# BUREAU OF MUNICIPAL AFFAIRS

# REPORT RE HOUSING

# FOR 1919

Comments by the Architectural Department.

PLAN "C."

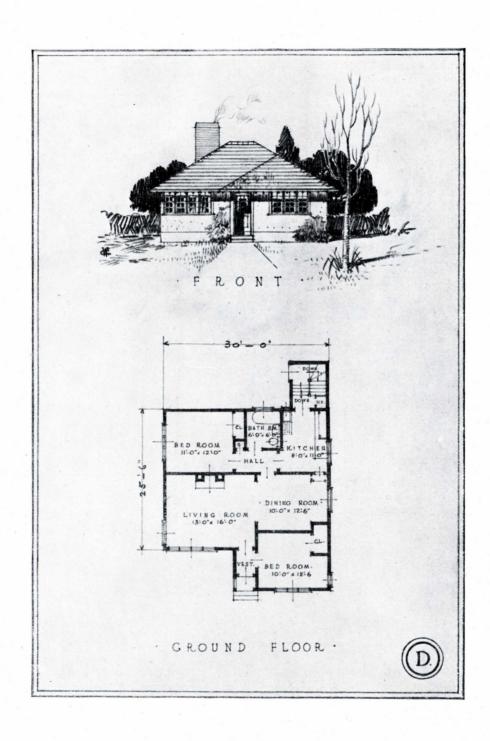
Some improvements to this plan might be considered as follows, viz.:-

#### PLAN "D."

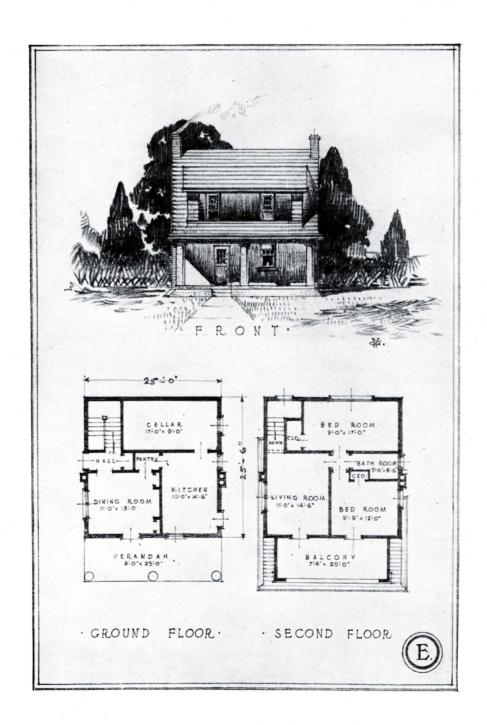
If the question of taking in a lodger was not considered, the door to the front bedroom would be better if made to open directly into the living room.

By arranging the front entrance door at the side of the vestibule it would have been possible to provide some coat hanging space.

In an ideal plan of this type, of course, both bedrooms and the bathroom should be off a common hall.

An improvement could also have been made to this plan by shifting the stair enclosure at the back so that another window could be worked in at the end of the kitchen to permit cross ventilation.

# PLAN "E."

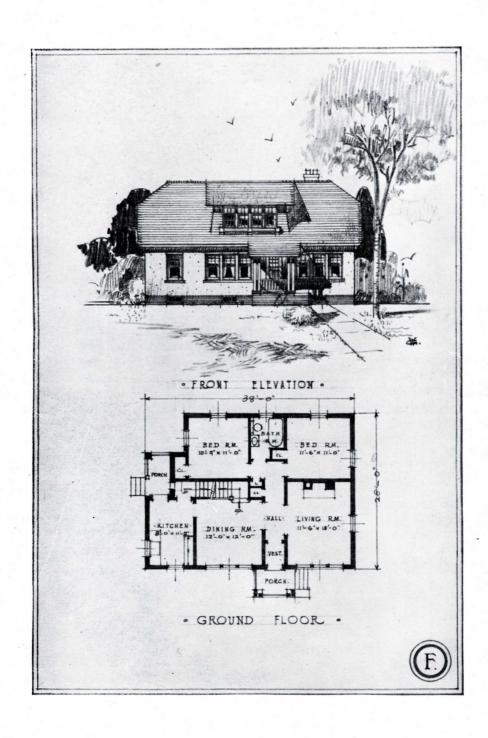
A small side window to provide cross ventilation for the back bedroom would have been an added improvement.

The heating of this house will present difficulties not found in ordinary types. Hot air heating of ground floor front rooms for example, will be difficult. With a hot water system the cellar floor level would require to be dropped sufficiently below the ground floor level to obtain the necessary rise to the pipes leading to the radiators.

The damp proofing which would be required under the ground floor would add quite an item to the cost.

## PLAN "G."

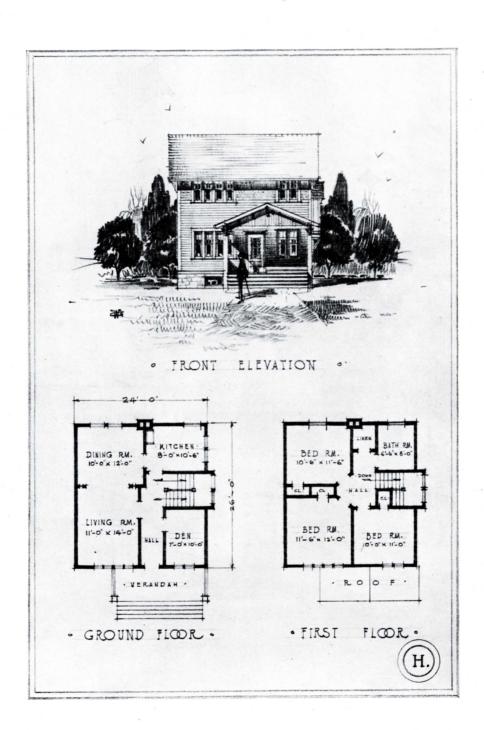
Cross ventilation has been provided for all rooms except the kitchen. This is unfortunate as the kitchen would be the hardest room to ventilate in the summertime and it should be the easiest.

This difficulty would be increased in most municipalities by the location of buildings on adjacent lot, and this plan, therefore, should not be used except where the foregoing objections have been overcome.

# PLAN "H."

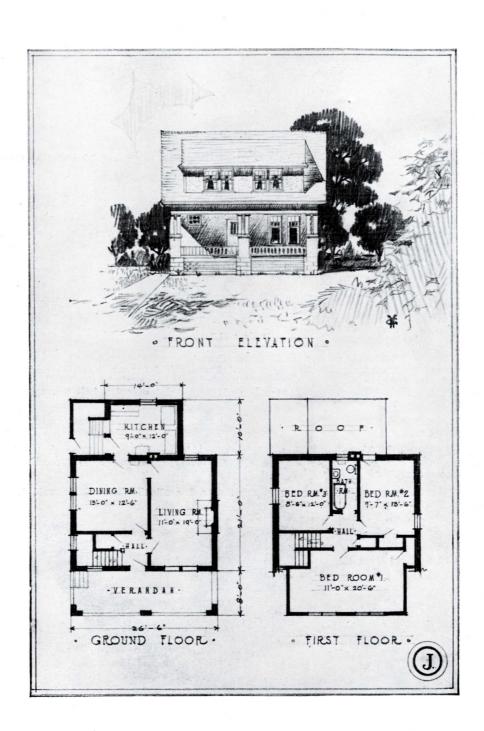
The over-all size of this house is larger than is required to get the areas of the rooms on the first floor according to the minimum called for under the Act. These over-all dimensions were likely determined by the desire to work in the small den on the ground floor. This, however, necessitated quite a lot of extra hall space to get past the den to the main stairway.

The front vestibule and the necessary coat hanging space should have been included in this plan.

A side entrance door should also have vestibule protection. A door at the top of the stairs leading down to the grade level would provide vestibule protection at side entrance door.

#### PLAN "J."

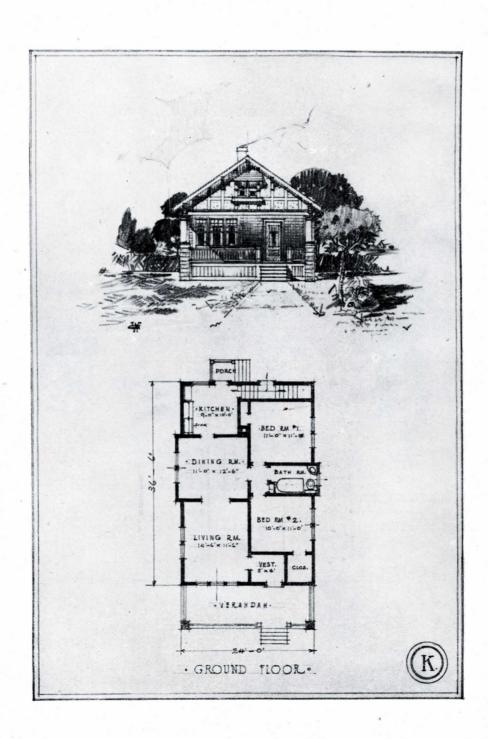
An improvement could have been made to this plan by the provision of a vestibule for the front entrance and means for getting cross ventilation in the kitchen and some of the upstairs bedrooms.

The roof of kitchen and the floor of the front bedroom will demand insulation not required of plans where the upper floor rooms are placed directly over the ground floor.

# PLAN "K."

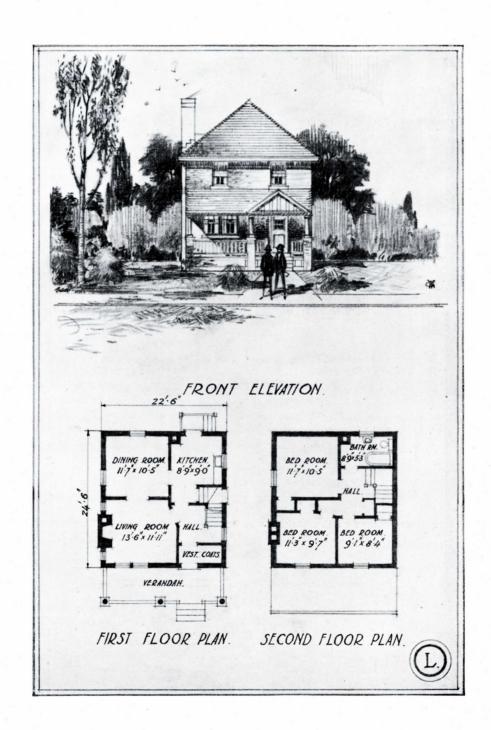
This is another three-room deep type of plan which is only suitable for very wide lots when so many of the rooms depend on getting light from the side.

On the average city lot, houses on the adjoining lots practically exclude all sunlight and ventilation from all the rooms shown with windows placed in the side walls.

PLAN "L."

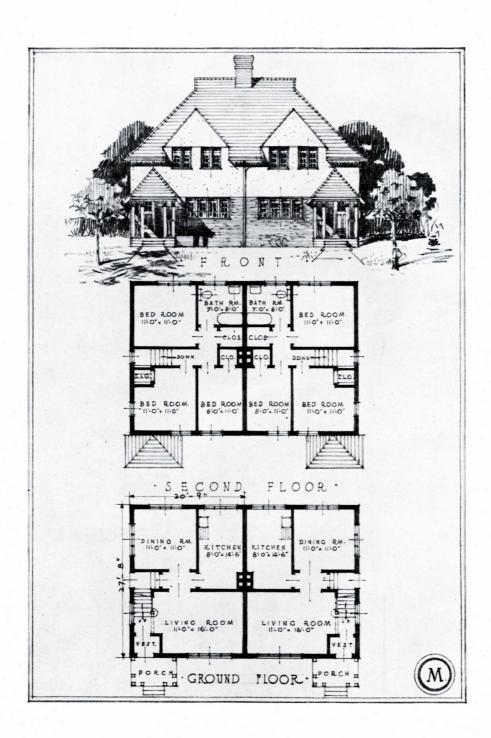
The upstair floor plan shows rather a large amount of hall space which could be cut down if it is desired to economize in space. A right angle turn with winders at the foot of main stairs would have allowed an increase of about three feet in the length of the kitchen.

# PLAN "M."

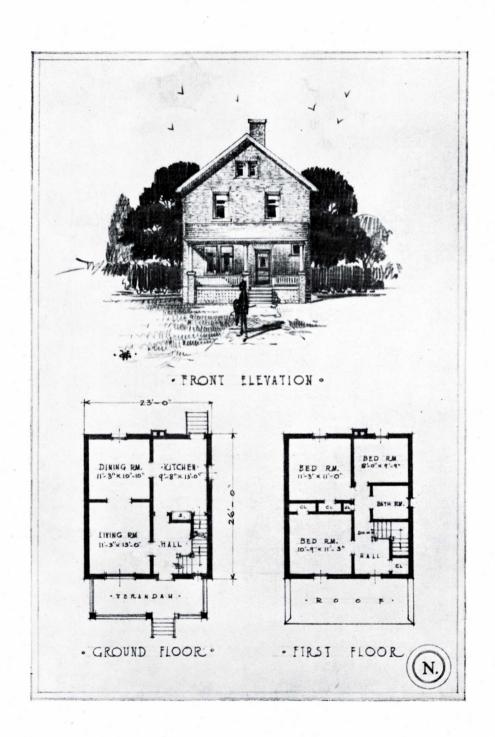
At very small extra cost a fireplace could have been provided in the angle of each of the living rooms.

In the bathroom the reversal of the positions of the w.c. and the basin would have brought the two soil stacks together and simplified drainage below.

#### PLAN "N."

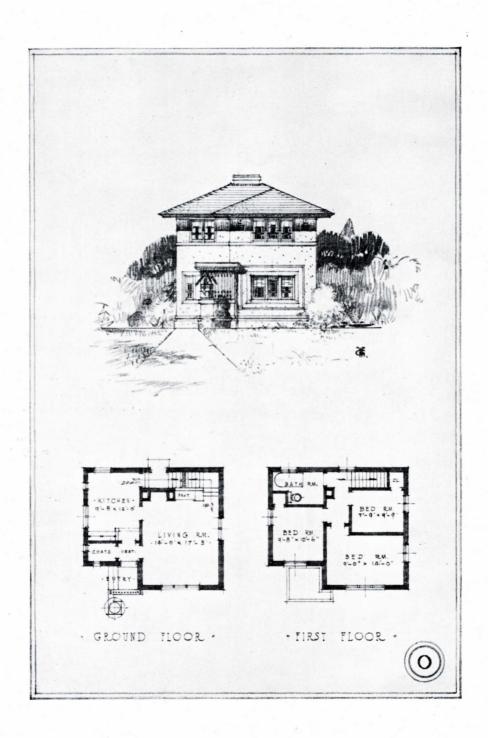
Over-all sizes of the plan could be slightly reduced and the areas and the rooms still be according to the minimum requirements of the Act.

There is quite a lot of waste hall space on both floors, and neither front nor rear entrances have vestibule protection.

More wall space could be obtained in the kitchen if the rear door was omitted and a grade entrance door worked in at the side under the main stairs, which is also required to give direct entrance to cellar.

The question of cross ventilation has been totally ignored.

# PLAN "P."

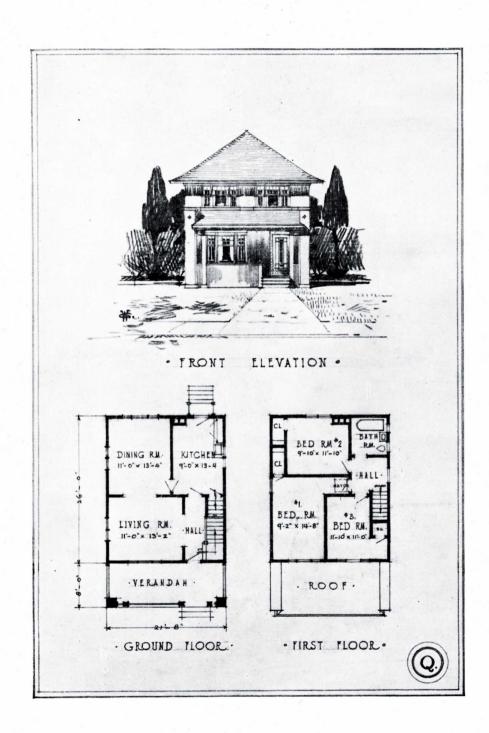
This plan is much larger in area than is needed to meet the requirements of the  $\operatorname{Act}$ .

The large area of the front hall is entirely unnecessary in a small house.

This plan lacks means to get from the outside to the cellar without passing through the house.

The area of the bathroom shown on the first floor is very wasteful.

Windows to get cross ventilation in the back bedroom and the small front bedroom would necessitate the building of extra dormers, which, if provided, would add to the cost.

PLAN "Q."

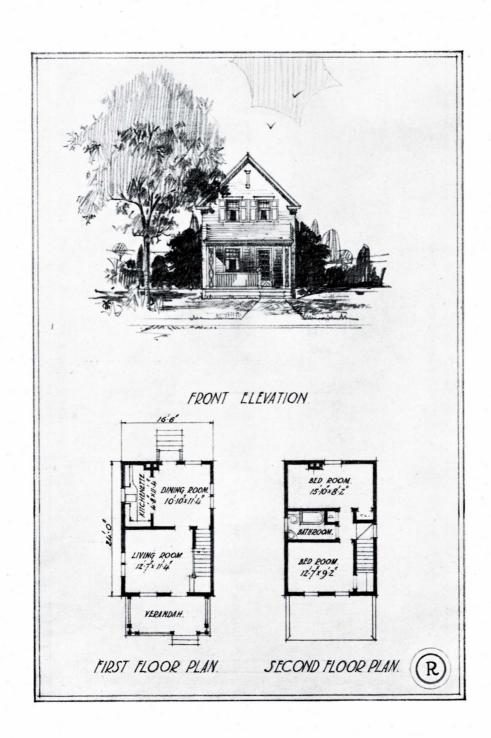
This is a square plan which differs very little from the average type. The depth of the plan could, of course, be cut down slightly without violation of the requirements.

Grade entrance to cellar and kitchen combined.

A window in place of rear door to kitchen.

More wall space in the kitchen, by moving the door from the kitchen to the hall three feet nearer to the front door and the door to the cellar stairs worked in on the side and the stairs starting off with winders to get to the cellar somewhat similar to the layout suggested on the Department's stock design "A."

#### PLAN "S."

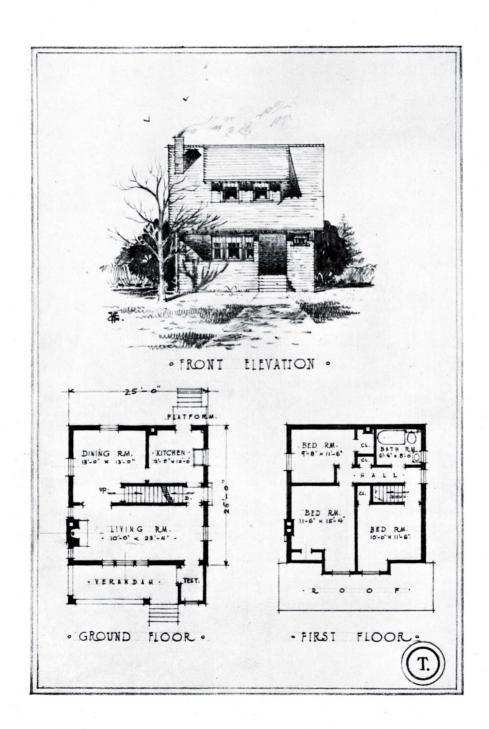
This example of the square plan is much larger than is needed to get the areas of the rooms according to the requirements of the Act.

There is much waste hall space.

The door from the kitchen to the front hall is also badly placed as it prevents furniture from being placed along the side walls for the length of about  $3\frac{1}{2}$  feet.

No clothes closets for two rear bedrooms are shown.

Note omission of side windows to provide cross ventilation for all the bedrooms.

PLAN "T."

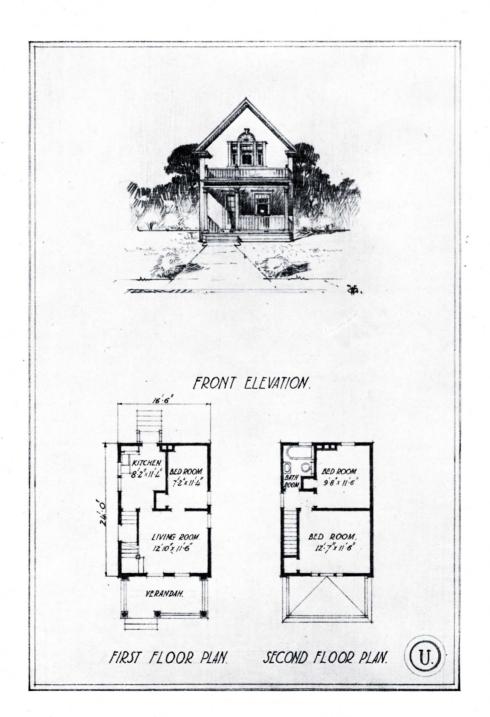
This plan is slightly larger than is required to comply with the regulations.

The living room is accountable for the extra size of the plan and should be reduced where low cost housing is desired. This room is too narrow, and this was only permitted because of the area.

PLAN "U."

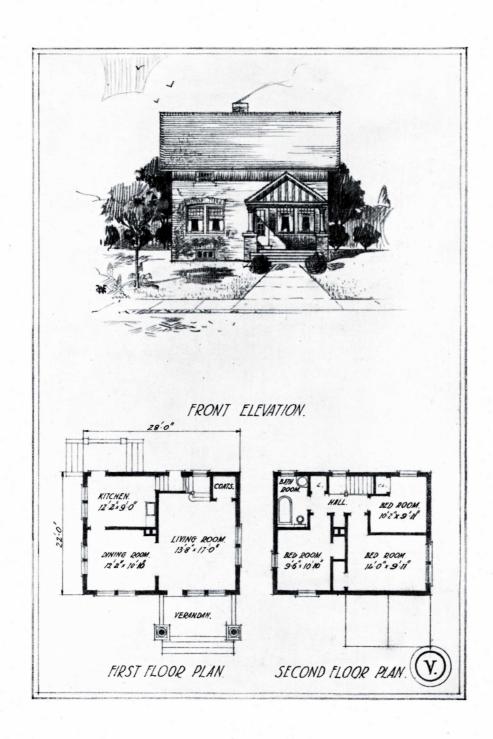
This plan lacks the necessary front vestibule accommodation and coat space, which could easily take the place of the costly verandah construction. It also lacks the side windows necessary for cross ventilation in the bedrooms.

## PLAN "X."

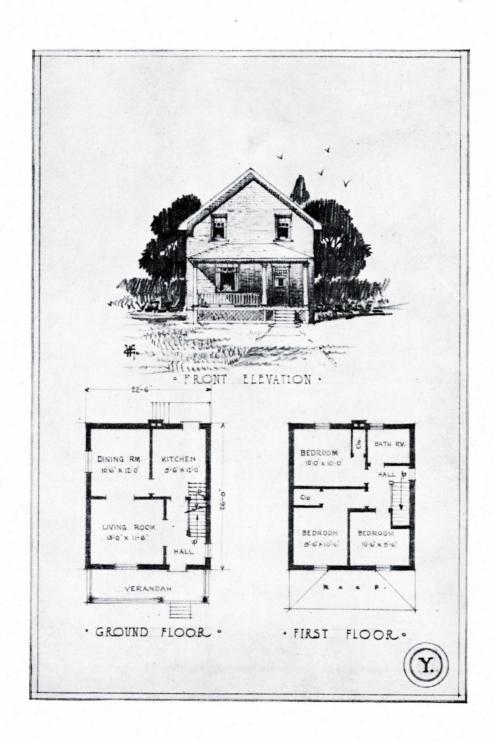
Some of the waste hall space on the ground floor should have been used to provide the necessary coat and vestibule space.

The lighting of kitchen and dining room with windows on opposite sides of the house would make this plan unsuited to the average sized lot.

## PLAN "Y."

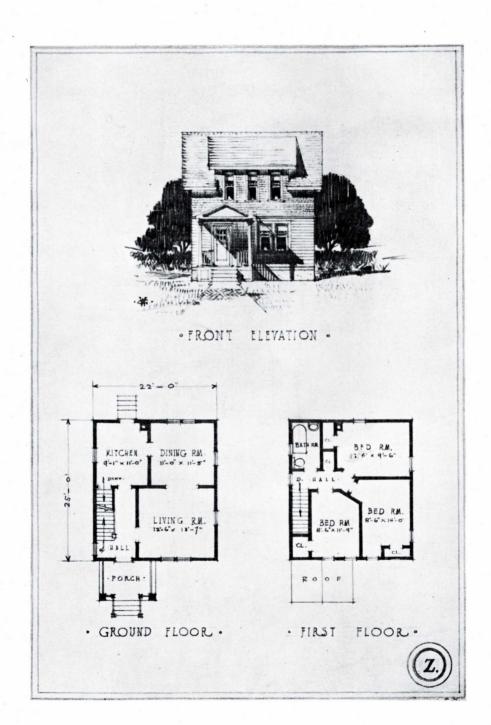
This is another example of the square planned type of the six-roomed house and lacks the necessary front vestibule and coat room accommodation, also the grade entrance door which would give outside entrance to the cellar and entrance to the kitchen. The rear entrance door to the kitchen could then be done away with to provide more wall space for the fittings.

When comparing this plan with the Department's stock design "A" it will be noticed that the outside dimensions of this house are a little larger than is necessary to get the areas of the rooms according to the minimum requirements of the Act.

PLAN "A1."

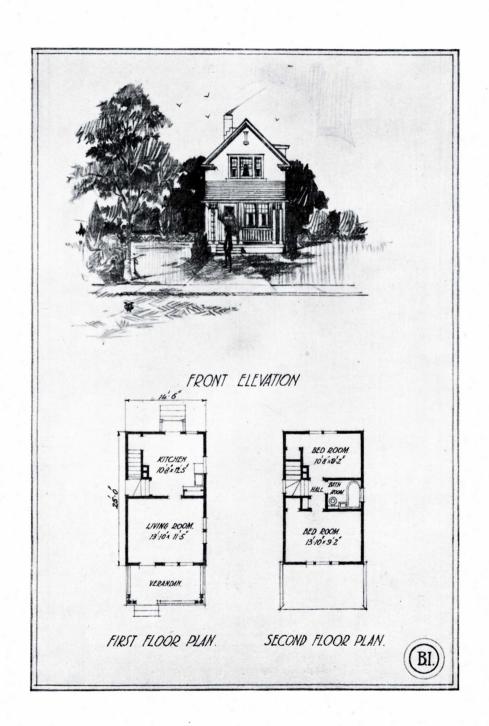
The door in the rear wall of the kitchen could have been done away with, considering that an outside grade entrance has already been provided at the side. This change would give just that much more available wall space for kitchen furniture.

It would be very difficult with this kind of a layout to provide satisfactory cross ventilation for any of the bedrooms.

# SAULT STE. MARIE, "L1."

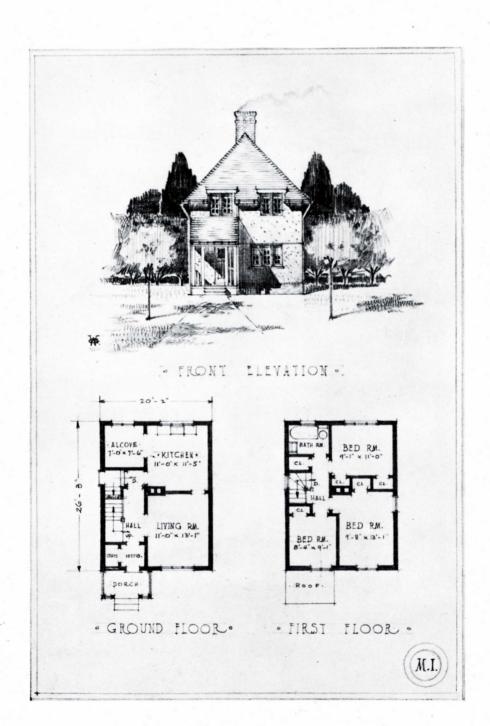
This is a typical six-roomed square plan type, but shows a great deal more hall space than is required on the ground floor.

The necessary front vestibule and coat space has been omitted.

REVISED PLAN, SUDBURY.

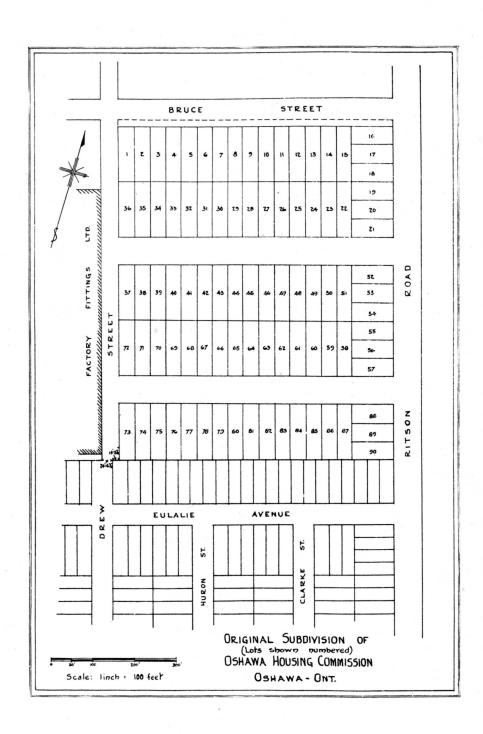
Above plan shows no consideration for existing grades, rock outcroppings, railway crossings, or economic shape of lots, created by special features such as railways, rivers, etc. It also includes twenty-foot lanes which are not desirable or necessary in housing developments.

This plan shows the location of streets and lots after giving consideration to the defects in the original gridinon plan illustrated.

Original plan submitted for approval of Railway Board and Housing Branch of Bureau of Municipal Affairs.

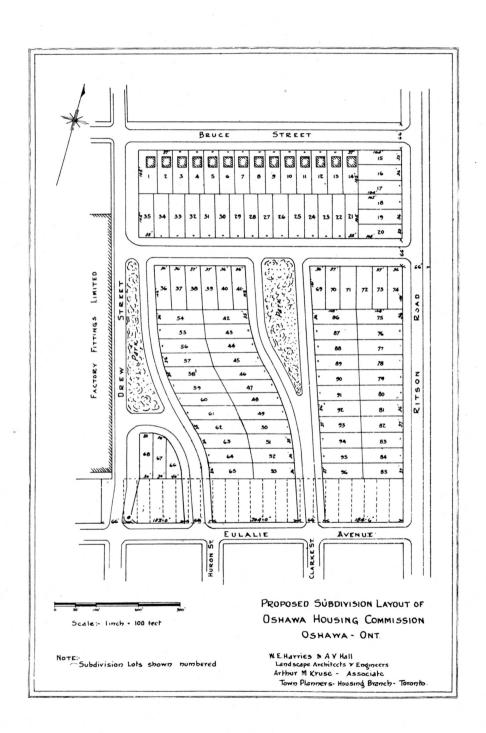
Objection was taken to the thoroughfare, Drew Street, being only 40 feet in width with two streets 66 feet wide opening into it, in addition to the fact that for practically the whole length of the property the wall of a factory had been built on the property line, thus preventing possibility of a future widening on that side.
